U.S. Department of the Interior
BUREAU OF LAND MANAGEMENT

Well Name: OUTRIDER 28 FED	Well Location: T24S / R32E / SEC 28 / SWSE /	County or Parish/State:
Well Number: 604H	Type of Well: OIL WELL	Allottee or Tribe Name:
Lease Number: NMNM016353	Unit or CA Name:	Unit or CA Number:
US Well Number: 3002550250	Well Status: Approved Application for Permit to Drill	Operator: XTO ENERGY INCORPORATED

Type of Submission: Notice of Intent

Type of Action: APD Change

13-3/8" x 9-5/8" x 5-1/2" 10M RSH-2 Wellhead
 Assembly, With T-EBS-F Tubing Head

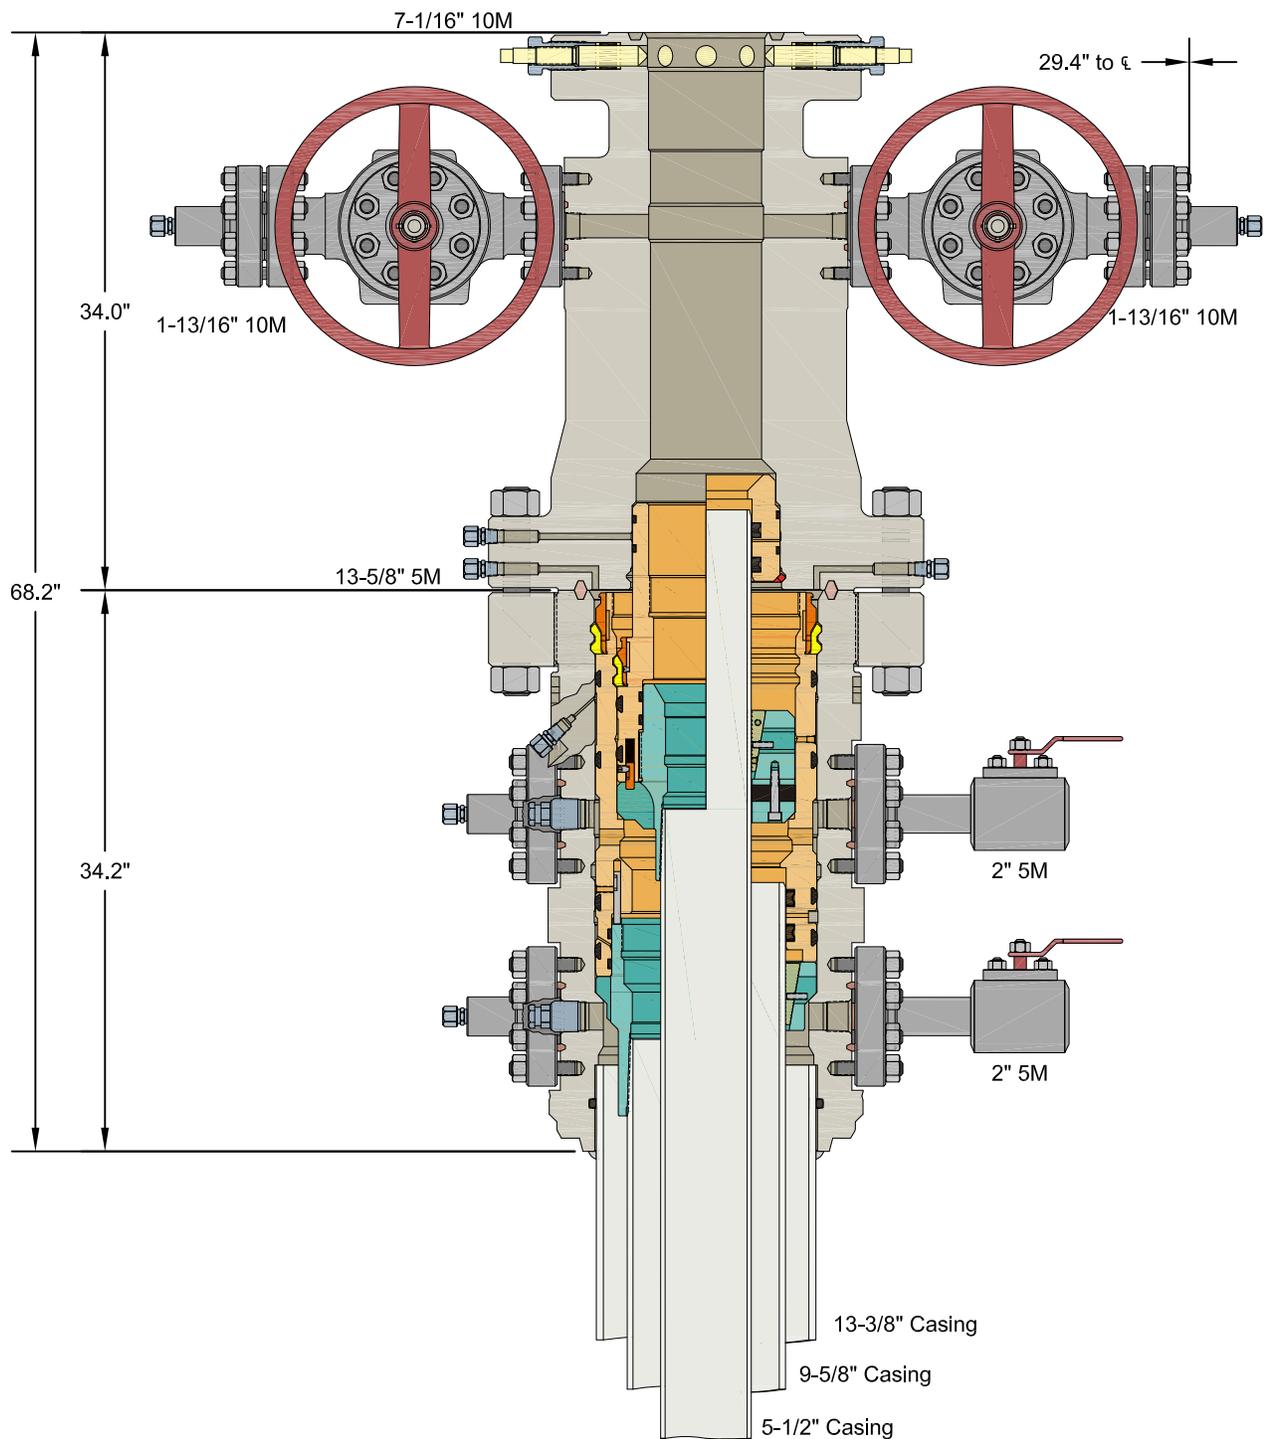
Wellhead:

Permanent Wellhead – Multibowl System

- A. Starting Head: 13-5/8" 10M top flange x 13-3/8" SOW bottom
- B. Tubing Head: 13-5/8" 10M bottom flange x 7-1/16" 15M top flange
 - Wellhead will be installed by manufacturer's representatives.
 - Manufacturer will monitor welding process to ensure appropriate temperature of seal.
 - Operator will test the 9-5/8" casing per BLM Onshore Order 2

· Wellhead Manufacturer representative will not be present for BOP test plug installation

1. Variance approved to use flex line from BOP to choke manifold. Manufacturer's specification to be readily available. No external damage to flex line. Flex line to be installed as straight as possible (no hard bends).'
2. Operator has proposed a multi-bowl wellhead assembly. This assembly will only be tested when installed on the surface casing. Minimum working pressure of the blowout preventer (BOP) and related equipment (BOPE) required for drilling below the surface casing shoe shall be **5000 (5M)** psi.
 - a. Wellhead shall be installed by manufacturer's representatives, submit documentation with subsequent sundry.
 - b. If the welding is performed by a third party, the manufacturer's representative shall monitor the temperature to verify that it does not exceed the maximum temperature of the seal.

- c. Manufacturer representative shall install the test plug for the initial BOP test.
- d. If the cement does not circulate and one inch operations would have been possible with a standard wellhead, the well head shall be cut off, cementing operations performed and another wellhead installed.
- e. Whenever any seal subject to test pressure is broken, all the tests in OOGO2.III.A.2.i must be followed.
